# **Planning and Zoning Board**

Case Information	
CASE NUMBER:	ZON18-00214
LOCATION/ADDRESS:	The 3100 to 3300 blocks of East Thomas Road (north side).
GENERAL VICINITY:	Located on the north side of Thomas Road and west of Val Vista Drive.
REQUEST:	Rezoning from AG and RS-43 to RM-2-PAD; and Site Plan Review, also consider the preliminary plat for "Lehi Cove"
PURPOSE:	This request will allow for the development of an attached single-residence development
COUNCIL DISTRICT:	District 1
OWNER:	Arthur L. Freeman Family Trust, Kaser Citrus, Inc., John Babiarz
APPLICANT:	Blake McKee, Skybridge Companies
STAFF PLANNER:	Evan Balmer, AICP
	SITE DATA
PARCEL NUMBER(S):	141-21-005P, 141-21-005R, 141-21-005Y and 141-21-005X
PARCEL SIZE:	7.5± acres
EXISTING ZONING:	AG and RS-43
GENERAL PLAN DESIGNATION:	Neighborhood: Suburban
CURRENT LAND USE:	Vacant
	SITE CONTEXT
NORTH:	Loop 202 Red Mountain Freeway
EAST:	Vacant – Zoned GI
SOUTH:	Existing single residence – Zoned RS-9-PAD

The applicant is proposing an 89 unit attached single-residence development. The site is located on the north side of Thomas Road west of Val Vista Drive. The subject property consists of four parcels. One parcel and a portion

# **Pedestrian Connectivity Concerns**

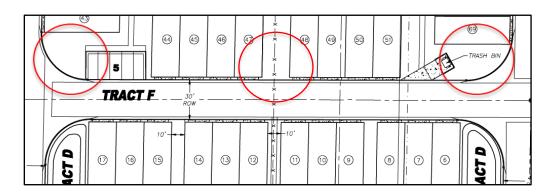
In order to create a more inviting experience and add some visual interest to the two internal alleys, staff would recommend adding a speed table and extending the landscaping along the pedestrian connections into the alleys between lots 32 and 33, lots 40 and 41, lots 64 and 65, and lots 74 and 75 as highlighted on the images below:

Another area that staff has concerns with is the internal pedestrian connection network. The applicant has included connections to the central amenity area from the east, west and north sides of the development, but there are still some areas of the development where the pedestrian connection is lacking. The southeast and southwest units specifically are only able to access the open space through the street network. Additionally, the parallel parking spaces on the perimeter of the development are lacking access to the sidewalk network. Staff would like to see some additional sidewalks added to provide a more robust pedestrian network. Some of the areas of concern are highlighted below.

- 1. Compliance with the basic development as shown on the site plan and preliminary plat submitted, except as modified below (without guarantee of lot yield, building count, lot coverage).
- 2. Compliance with all City development codes and regulations, except as modified in Table 1 of the staff report.
- 3. Compliance with all requirements of the Subdivision Technical Review Committee.
- 4. Prior to submitting for a building permit, submit a revised site plan for Planning Director review and acceptance that includes:
  - a. A reduction of the alley to a width of 24' and enhanced landscaping and speed tables between the following lots:
    - 32 and 33
    - 40 and 41
    - 64 and 65
    - 74 and 75
  - b. Enhanced pedestrian network from the central open space area to the following areas:
    - Southeast building

- Southwest building
- On-street parking locations
- 5. Compliance with the building elevations and floor plans as submitted.
